NOTICE: TO ALL OWNERS OF OCTAVE SYNTHESIZERS

To help make Octave Synthesizers better suit your personal needs, certain custom modifications are now available subject to the following terms:

M-02 12/24 dB/octave FILTER SLOPE

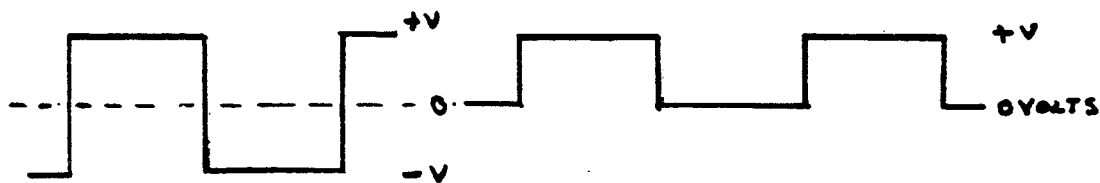
A miniature toggle switch is added to the VCF module. In one position, the VCF rolloff is 24dB/octave, as it normally is, and in the other position the rolloff becomes 12dB/octave.

M-06 LFO DELAY

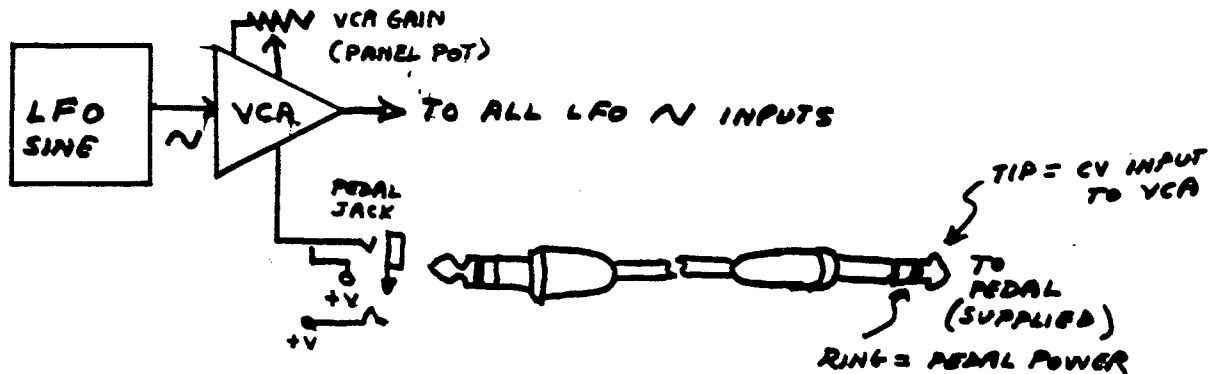
A rotary potentiometer is added to the front panel of the A-1000 series CAT synthesizer to control the delay time of the LFO sine wave. This delay is trigger sensitive and is continuously variable from 0 to 5 seconds. The resulting effect is similar to that of the SRM and Kitten LFO delay.

M-10 INTERFACE PEDAL INPUT (includes foot pedal)

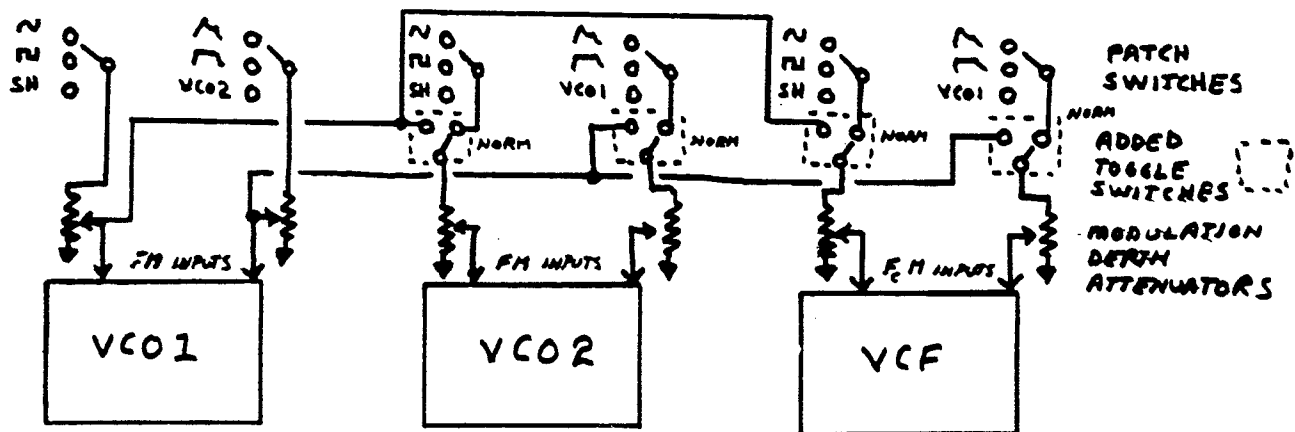
A stereo jack is added to the rear of the instrument. The tip of this jack provides a 1 volt per octave input to the interface circuitry on the synthesizer. A voltage applied to this jack will shift the pitch of the entire unit in the same way as the pitch bender shifts the pitch of the entire unit.

When the pedal supplied is inserted into this jack, the pitch of the unit can be bent upwards with it. The range of the pitch bend is controlled by the sensitivity control on the pedal.

M-12 2-NOTE MEMORY

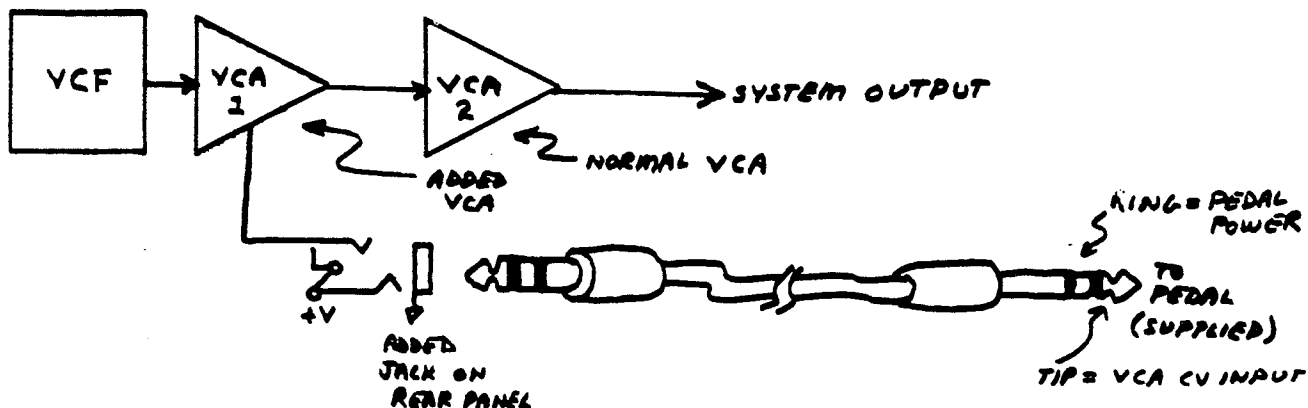
The CAT series A-1000 memory system is upgraded to that of the SRM by adding a memory to the second note. The keyboard and internal memory circuitry are replaced (factory retains old keyboard) with the new SRM keyboard and circuitry. The external appearance of the unit is not altered.

The second memory allows the CAT second voice to be memorized after releasing the key so that both oscillators maintain the interval that was played before the keys were released.

M-17 KEYBOARD TRIGGERING OF AUTO S&H

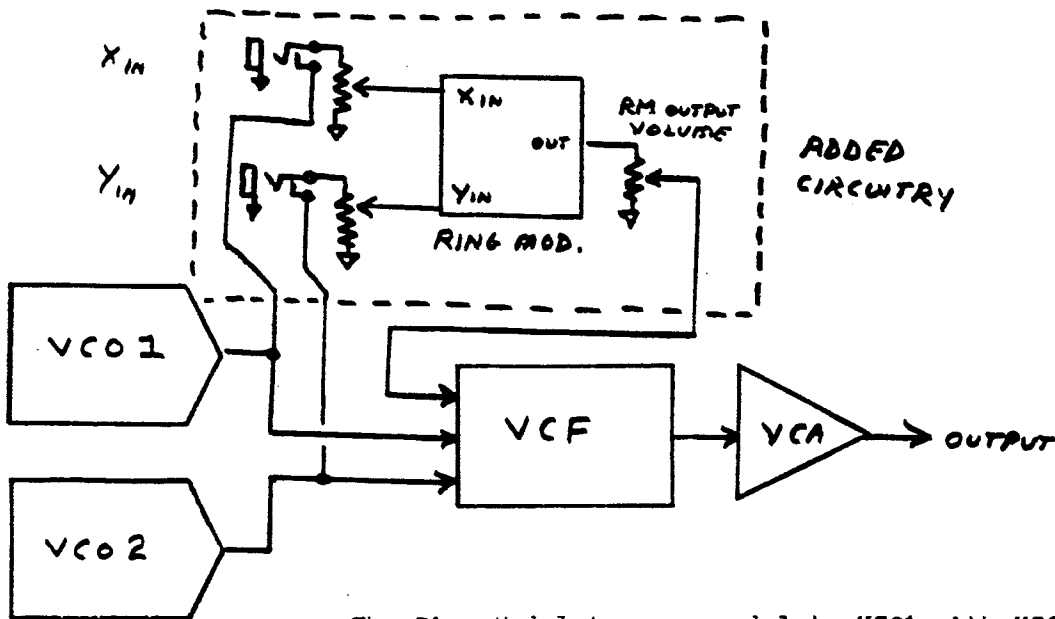
A miniature toggle switch is mounted near the S&H switch. In one position, the S&H is triggered by the LFO, as it normally is. In the other position, the keyboard trigger controls the S&H and a new sample is taken on every keyboard trigger.

M-20 VCO1, VCO2, NOISE SERIES OUTPUTS

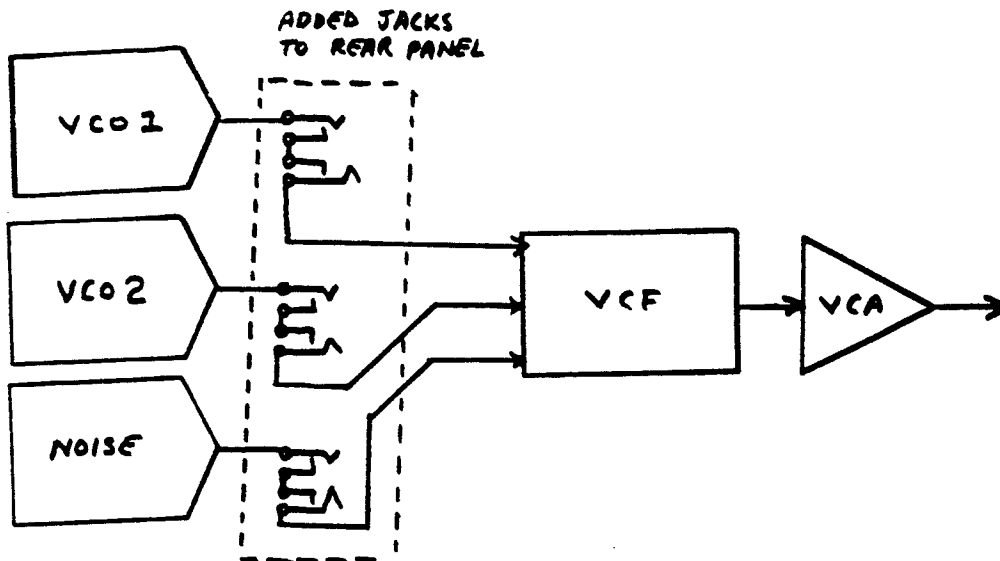
Three stereo jacks are added to the back of the unit to allow access to the outputs of VCO1, VCO2 and noise for processing by external modifiers. The jacks are connected in such a way that if a stereo cable is plugged in, the tip of the stereo cable is the output of the respective module, and the ring is the input back into the VCF. This allows modifiers such as phase shifters, delay lines, fuzz boxes etc. to be placed in series between either VCO1, VCO2, or the noise and the VCF.

By adding these patching jacks, external modifiers can be connected in series with the sound sources.

M-21 VCF BYPASS SWITCHES FOR VCO1, VCO2, AND NOISE

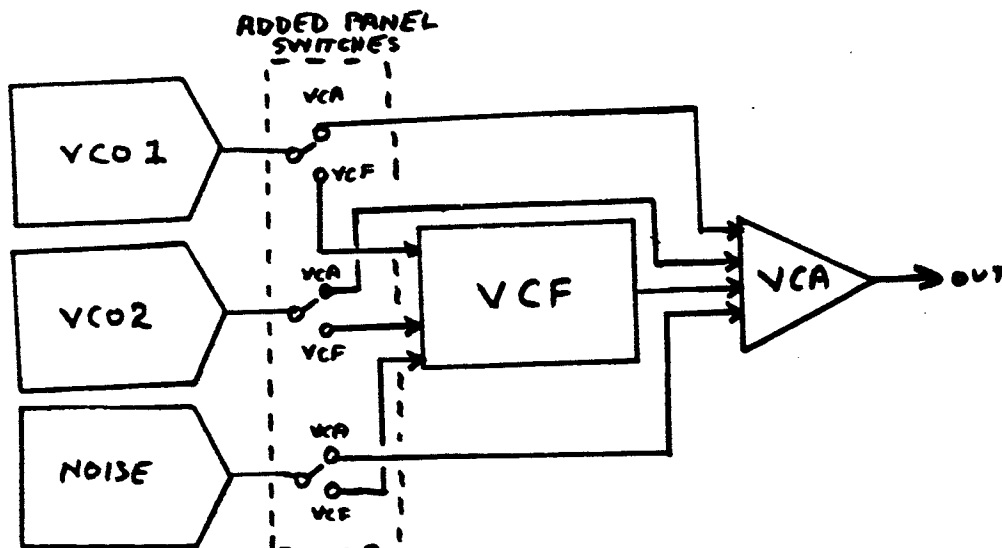
Three miniature toggle switches are added to the panel to allow the noise, VCO1 and VCO2 modules to bypass the VCF and instead go directly to the VCA. This allows certain modules to be modified by the VCF and others to be unaffected, thus extending the ability to create complex timbres.

By adding these bypass switches, the sound sources can bypass the VCF and go directly to the VCA

M-22 INPUT/OUTPUT PATCHING SYSTEM

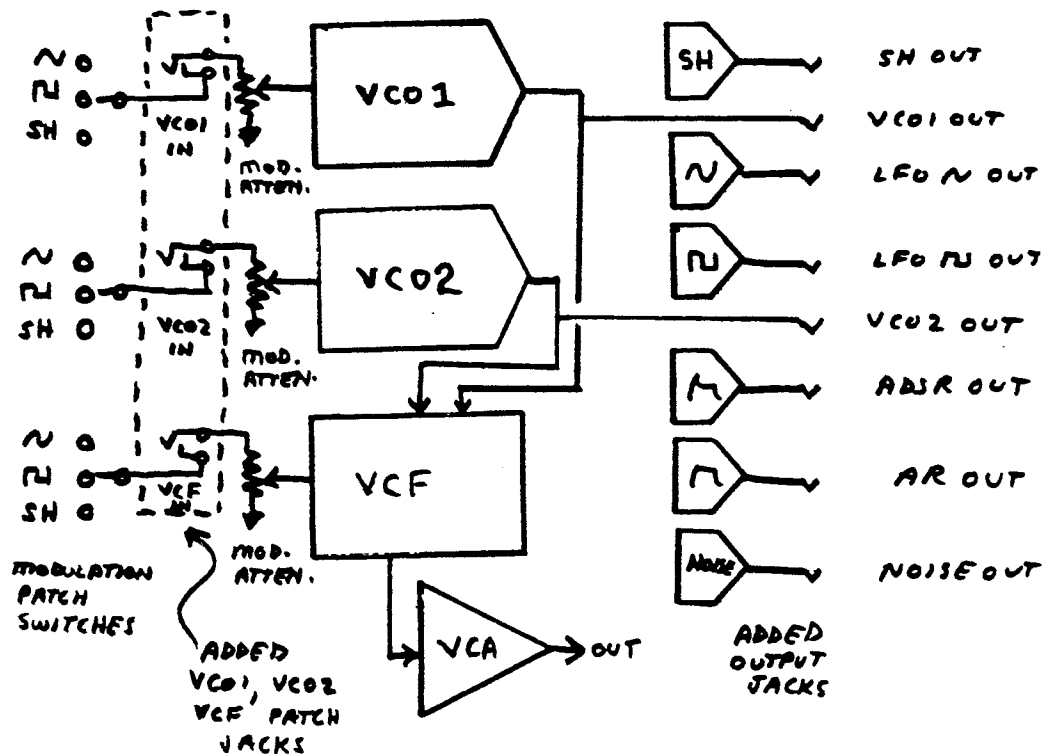
The outputs of the LFO sine, square, ADSR, AR, S&H, VCO1, VCO2 mixers and noise are brought to back panel jacks without disrupting their initial internal connections. This allows access to all of these modules for external processing. VCO1, VCO2, and VCF each are given an external extra modulation input for a total of 11 jacks.

These three inputs are connected in series with the first patch switch and modulation attenuator for VCO1, VCO2 and VCF. When a plug is inserted into one of these jacks, the mod source switch is disconnected and replaced by the external mod source. The attenuator normally corresponding to the disconnected mod source switch controls the external input mod depth. This mod is suggested for electronic music studio applications since it allows much more modulation capabilities and integrated processing of synthesizer signals with external modifiers.
